Certificate of Appropriateness

128 W. BROWN ST. Brewers Hill Historic District

PTS ID 114371 COA: porch work

Top rail options.

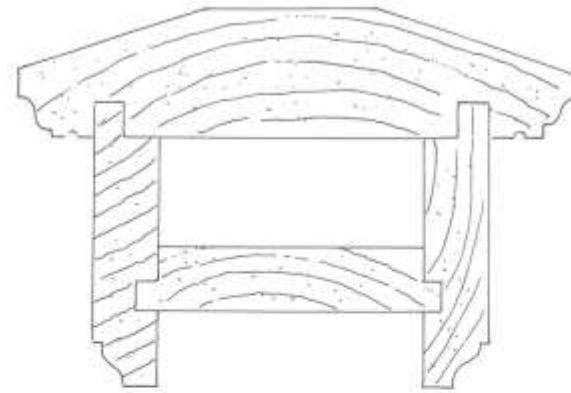
Top rail *option* with mandatory bottom rail design and minimum required design for newels.

Basic Railing and Newel Post Design

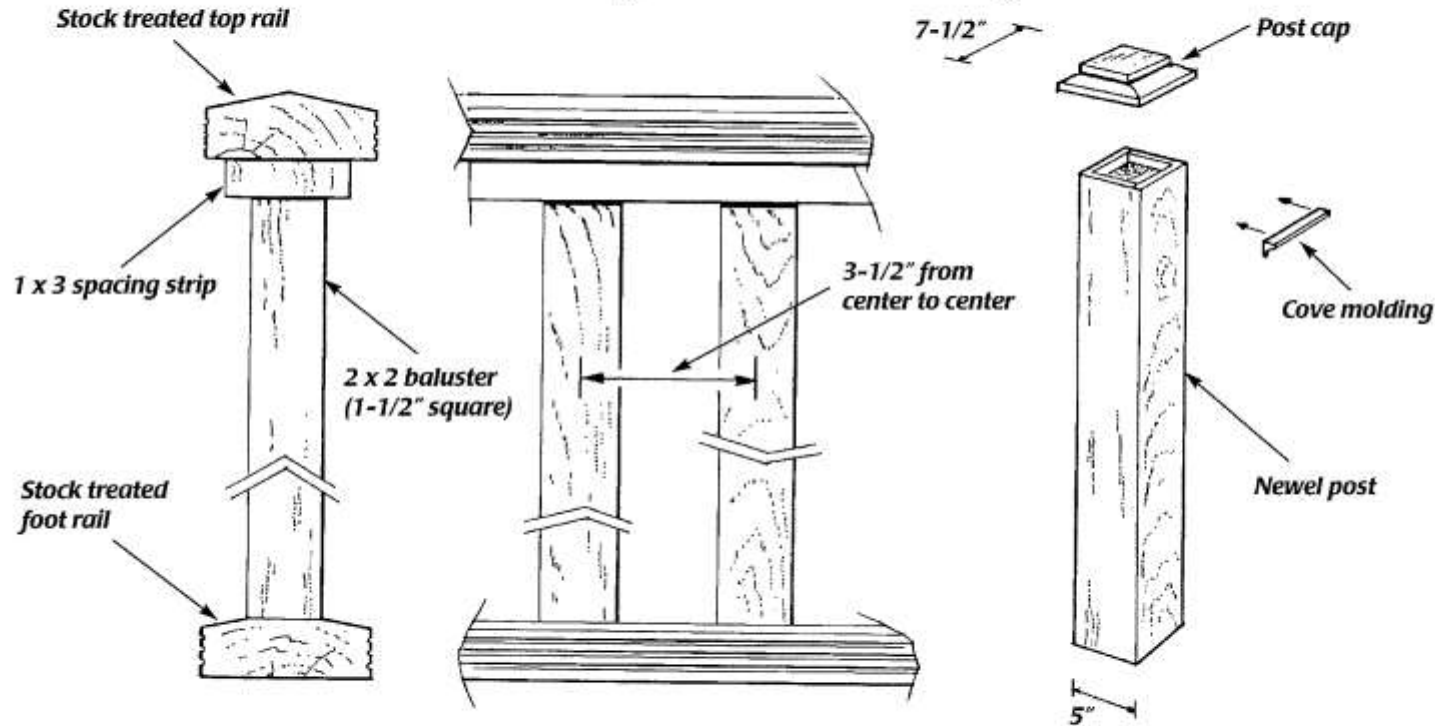
The number of historic handrail and newel post designs is literally endless. The above designs are appropriate for many houses built before 1940 and would be approved by the Historic Preservation Commission for most homes.
